APPLICATION NO.	FILING DATE	FIRST NAMED INVENTOR	ATTORNEY DOCKET NO.	CONFIRMATION NO.
10/604,008	06/20/2003	Steven J. Berry	71501-0002	1007

Office Action Summary

This is the **Final Office Action** for application number 10/604,008 Gas Cylinder Base, filed on 6/20/03. Claims 1-32 are pending. This **Final Office Action** is in response to applicant's reply dated 10/29/04. The text of those sections of Title 35, U.S. Code not included in this action can be found in a prior Office action.

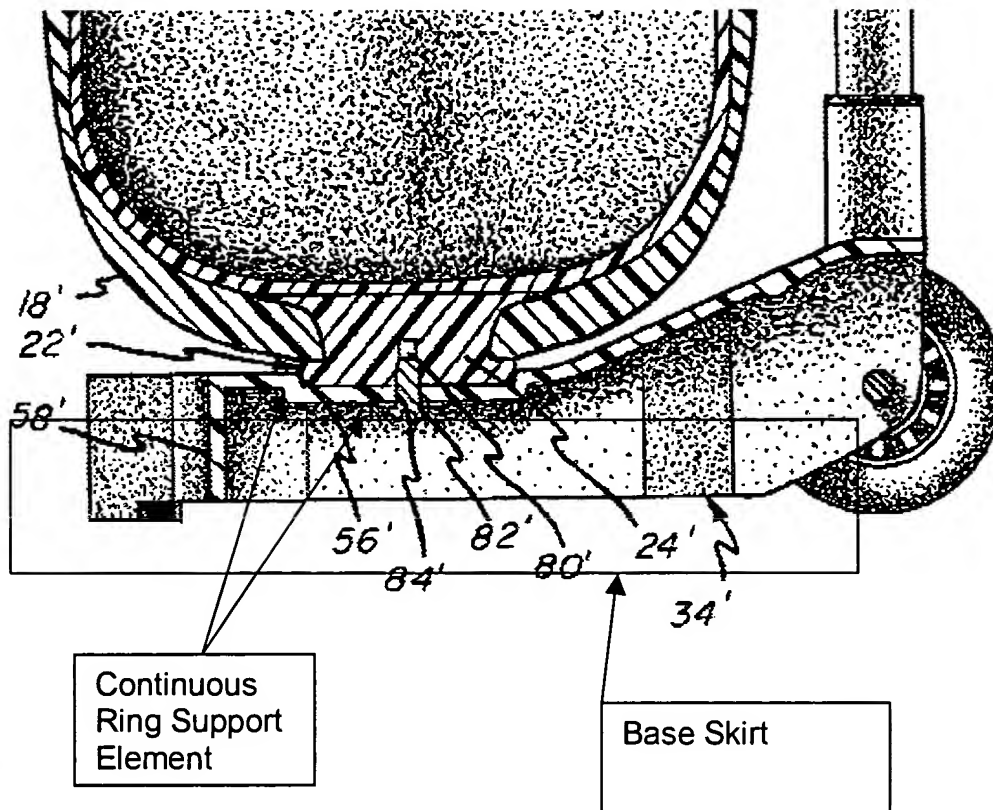
Claims 1-5, 7-10, 17-21 and 23-26 are rejected under 35 U.S.C. 102(b) as being anticipated by United States Patent No. 6508477 to Burkett to the embodiment shown by Figs. 6-9.

The patent to Burkett discloses a gas cylinder (14'), the cylinder having a base ring (22', 24') with a threaded aperture therethrough (80'), the base having a base skirt (including a portion of 42'), having a first lateral dimension, which is greater than the diameter of the cylinder (14') and a continuous ring support element (See Drawing Below), the support element which extends upwardly from the base skirt and which defines a second lateral dimension less than the first lateral dimension and a threaded fastener (82') inserted in a threaded aperture (84') therethrough in the support element and in the threaded aperture (80') of the base ring (22' 24') of the cylinder, for attaching the gas cylinder to the base by engaging the base ring of the cylinder, the fastener (82') having a point at an end which engages the base ring (22', 24').

The applicant has also argued that the Burkett reference does not show a base skirt, the ring extending upwardly from the base skirt. The drawing above has added emphasis to show that a portion of (42') is considered the base skirt, the ring extending from that bottom/base portion as clarified above, this argument also being unpersuasive.
